- 1.1 This addendum modifies the Bid Documents for the Jennie E. Hughes Park Improvements project.
- 1.2 This Addendum forms a part of the Bidding Documents and will be incorporated into the Contract documents, as applicable.
- 1.3 Acknowledge receipt of all addenda prior to submittal of bid, by reference in the bid form.

JENNIE E. HUGHES PARK IMPROVEMENTS
6448 Sewanee Ave.,
West University Place, TX 77005

NO.	DATE:	DESCRIPTION:
	3/6/2018	100% Construction Drawings
	4/11/2018	Addendum #1

L0.01

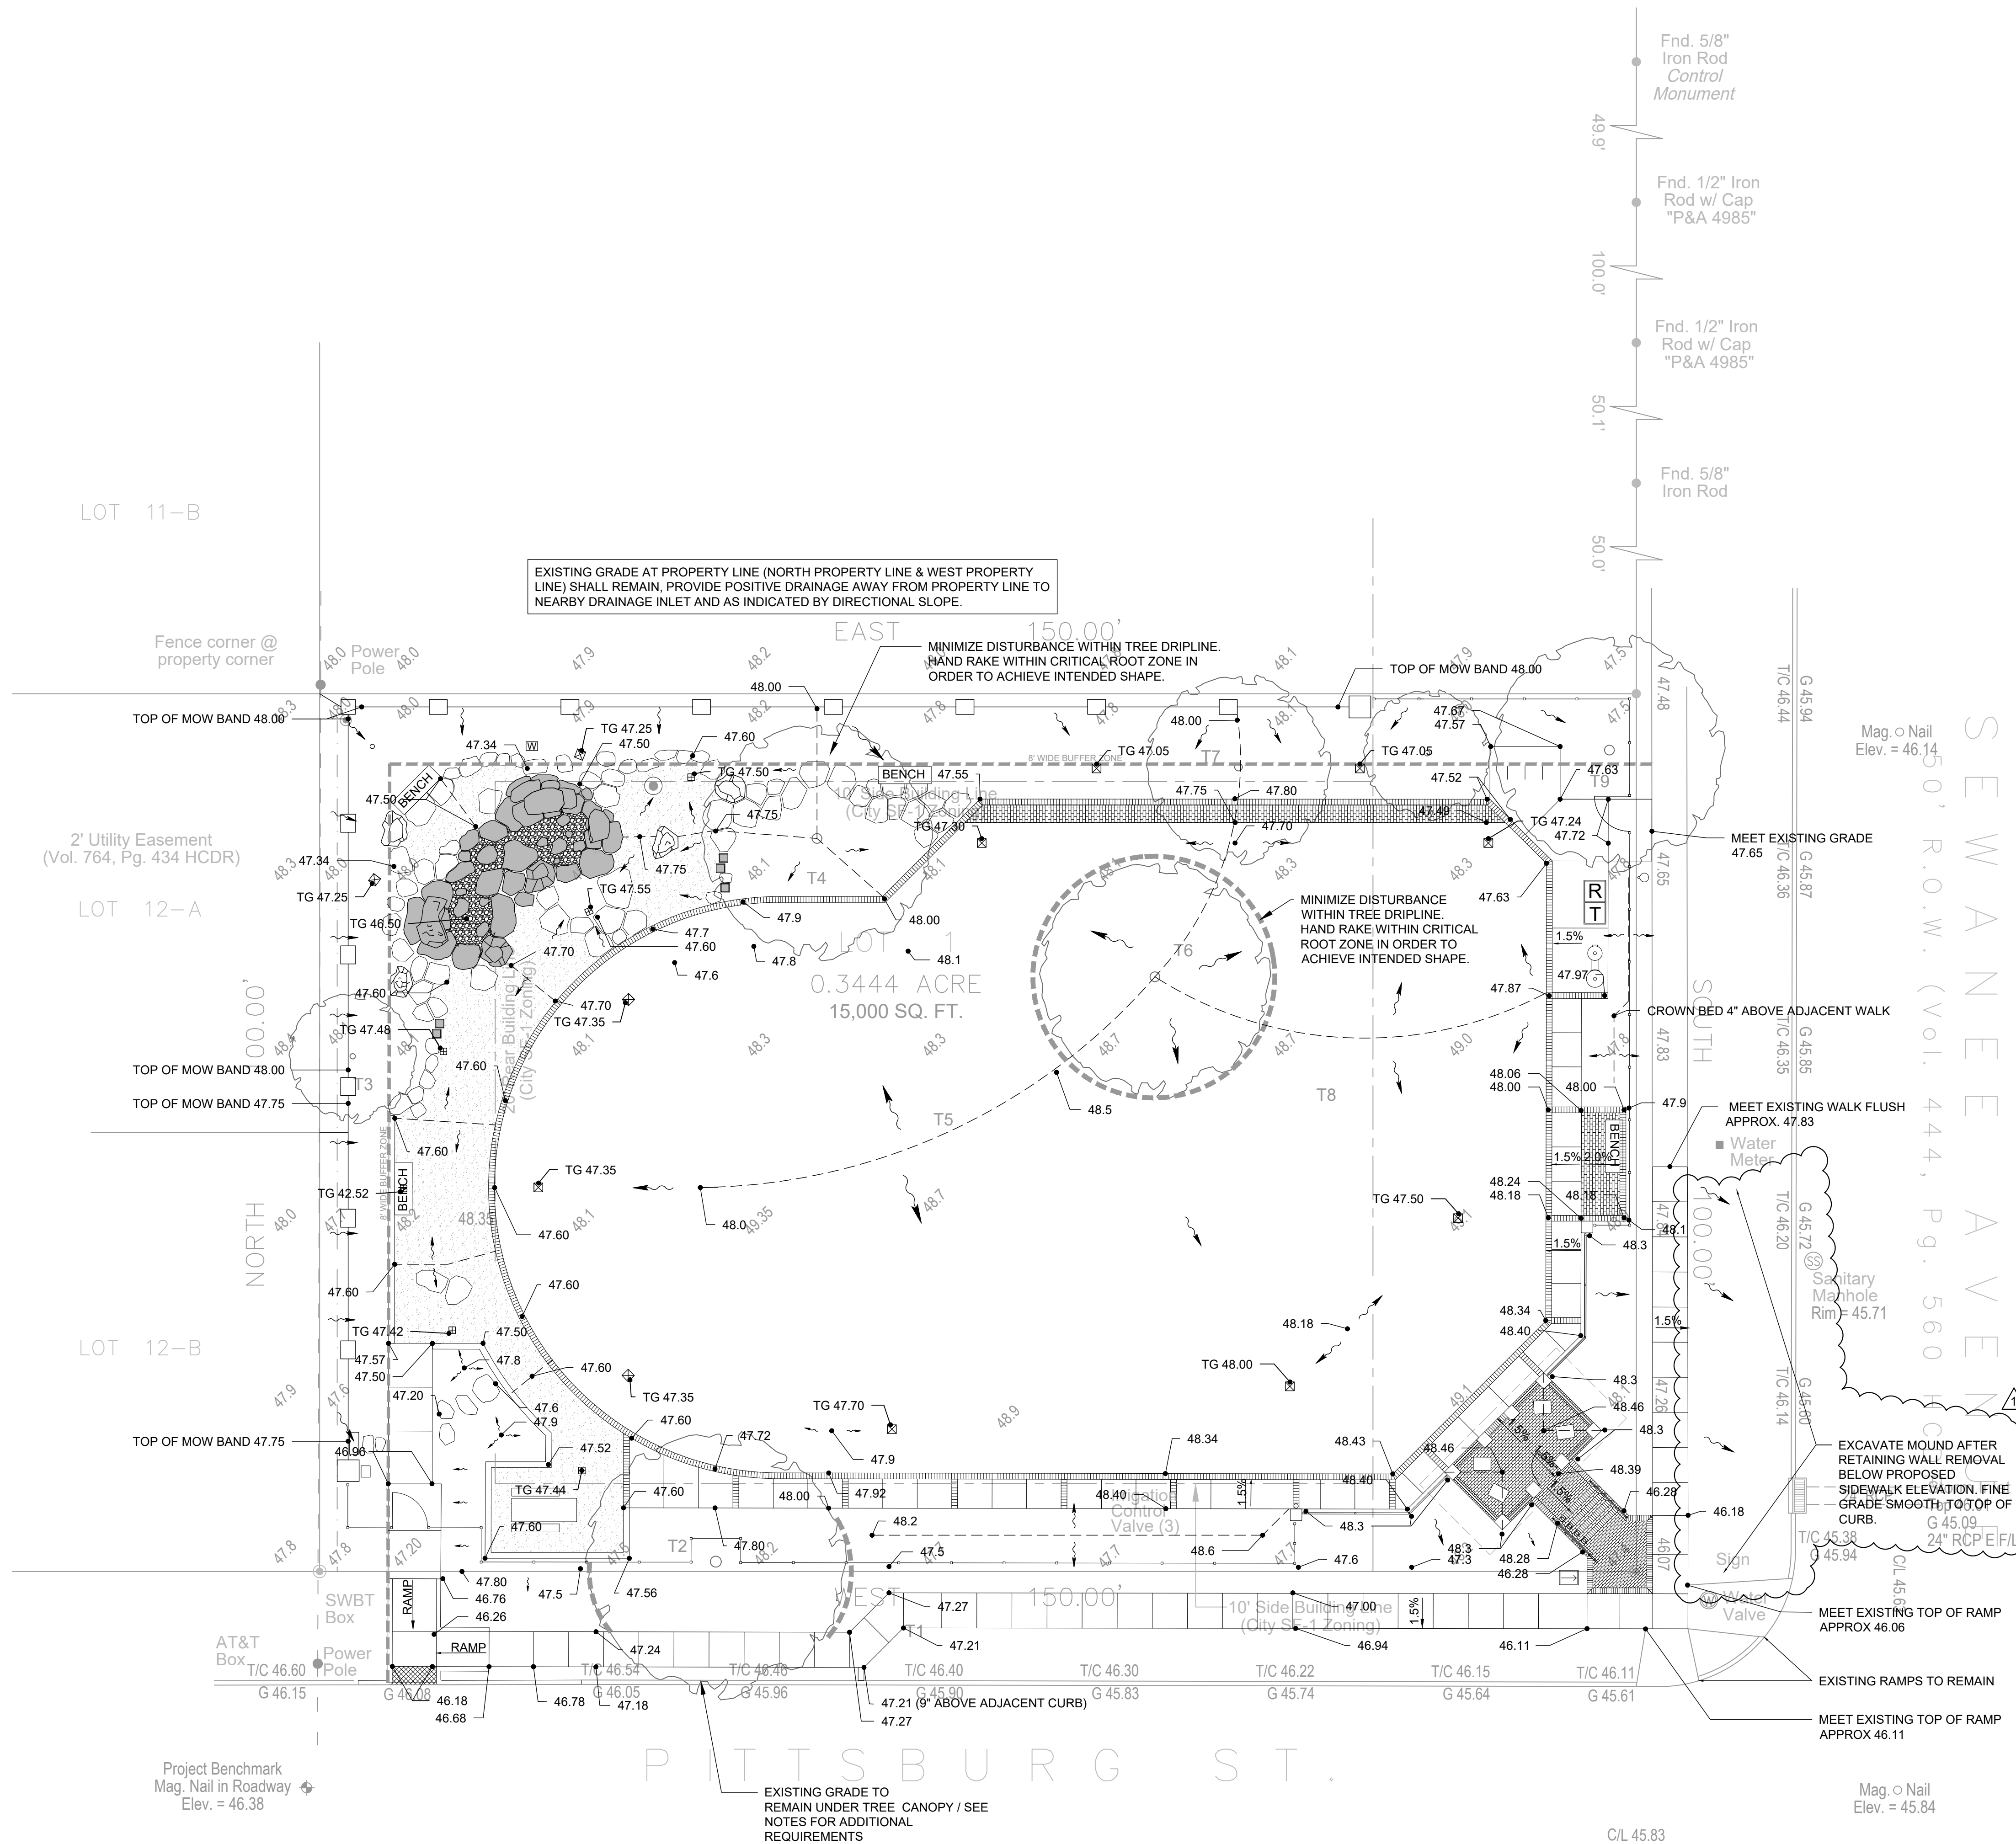
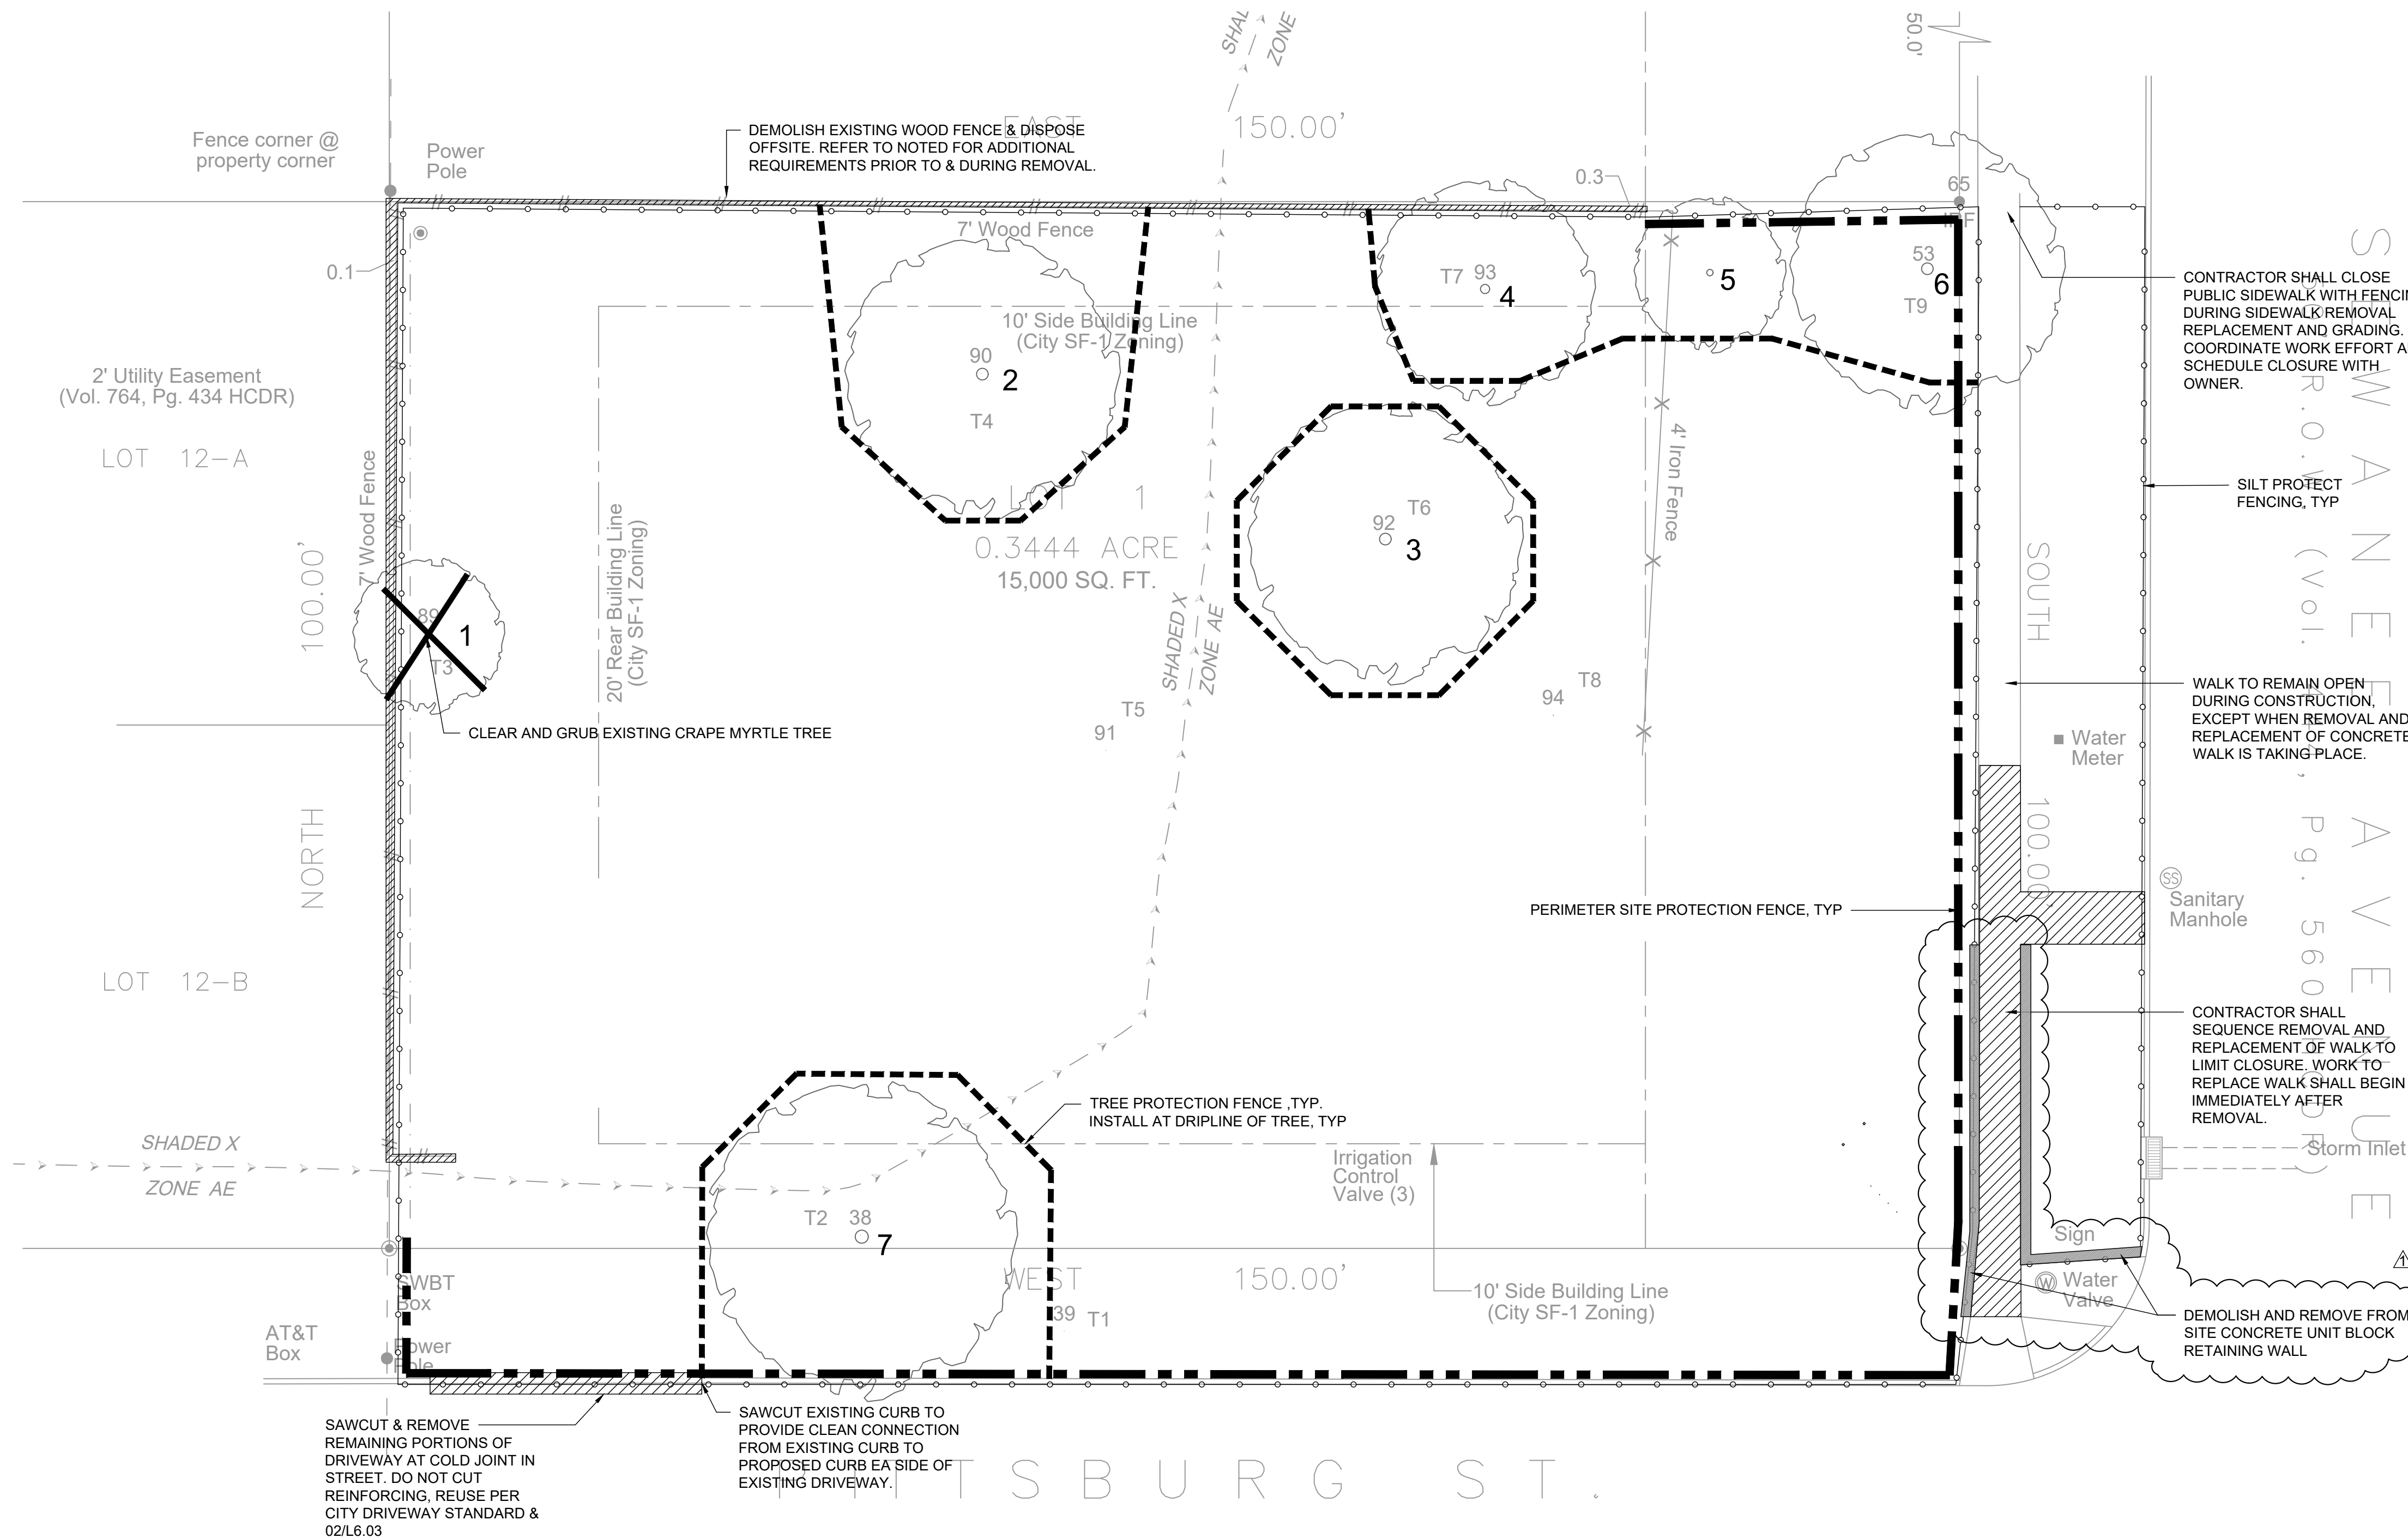
- 3.1 L0.01 - Demolition of concrete unit retaining wall added to scope.
- 3.2 L3.01 – Description of grading work between sidewalk and street curb at previous retaining wall locations provided.
- 3.3 L6.04 – Raindrop representative added to notes. Revised activator bollard model number. Control Panel Timer model number provided. Description of conduit routing provided within detail 01.
- 3.4 L6.23 – Detail path callout revised.
- 3.5 LE1.01 – Service size revised. Additional notes provided. Description of conduit routing provided for activator bollard and water feature valve.
